CITY OF ALBUQUERQUE

**Re: ABQ Moving & Storage
5001 Paseo Del Norte NE
Requested for Permanent C. O. - Accepted
Engineers Stamp Date 12/8/15 (C17D124)
Certification dated: 4-18-16**

PARKING LOT GRADING PLAN

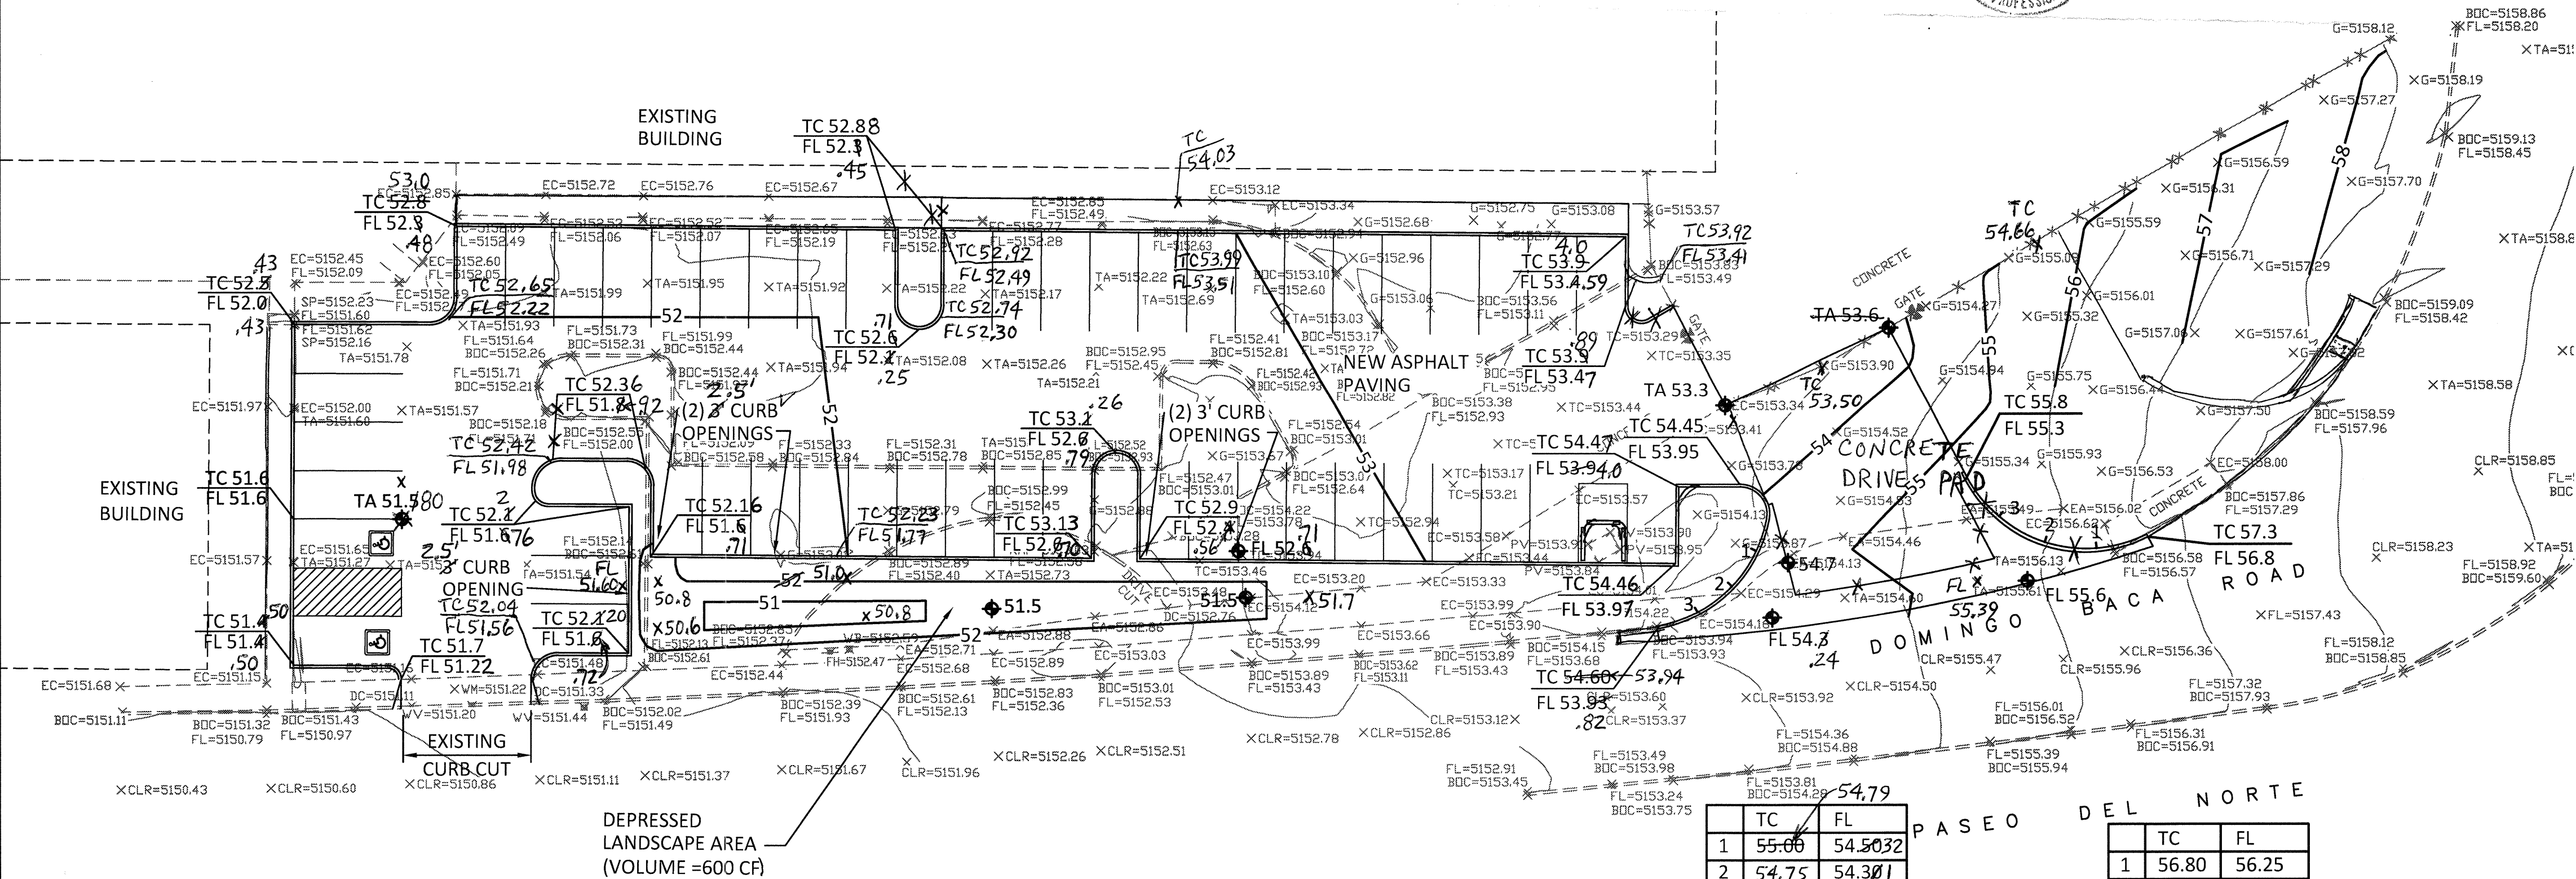
Based on the Certification received on 4/21/2016, the site is acceptable for release of Certificate of Occupancy by Hydrology.
